PLANNING CONSULTATION RESPONSE

Application No	2026/0606
Proposal	Reserved Matters application (with layout, scale, landscaping and appearance under consideration) for the erection of 173 dwellings, laying out of open space and associated infrastructure pursuant to outline planning consent 2024/0122 (Appeal APP/R4408/W/25/335991): Outline planning application for demolition of existing structures and erection of residential dwellings with associated infrastructure and open space. All matters reserved apart from access into the site
Address	Land north of Hemingfield Road, Hemingfield, Barnsley
Date of Consultation Reply	04/09/26
Consultee	Highways DC

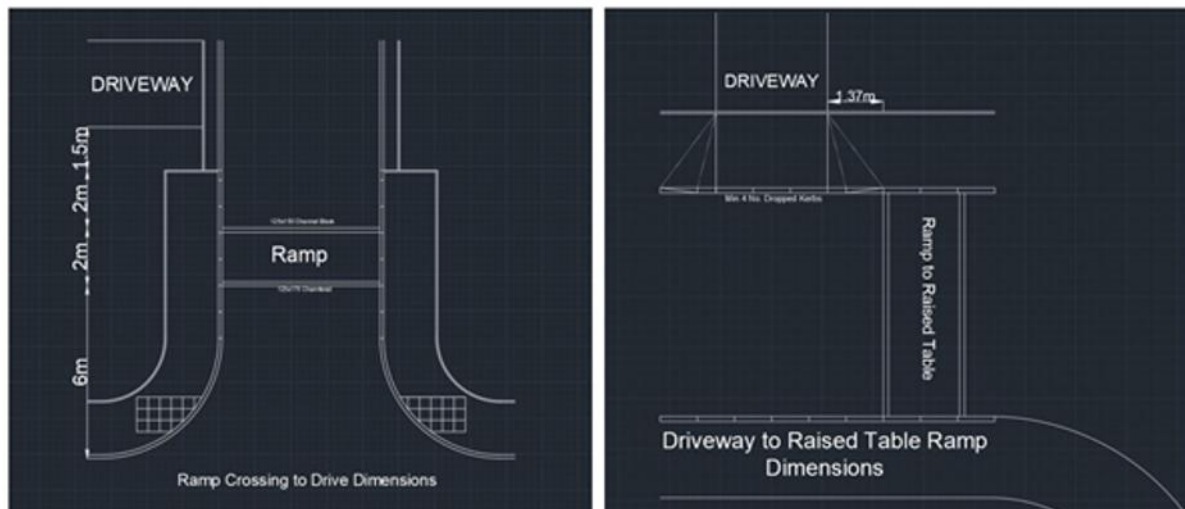
- The Council's Section 38 engineers have made comment on the location and extents of almost all the tables proposed. The layout drawing with informal notes from the S38 will be sent to the planning officer, but many tables do not conform to the below design standards, and these should be followed:
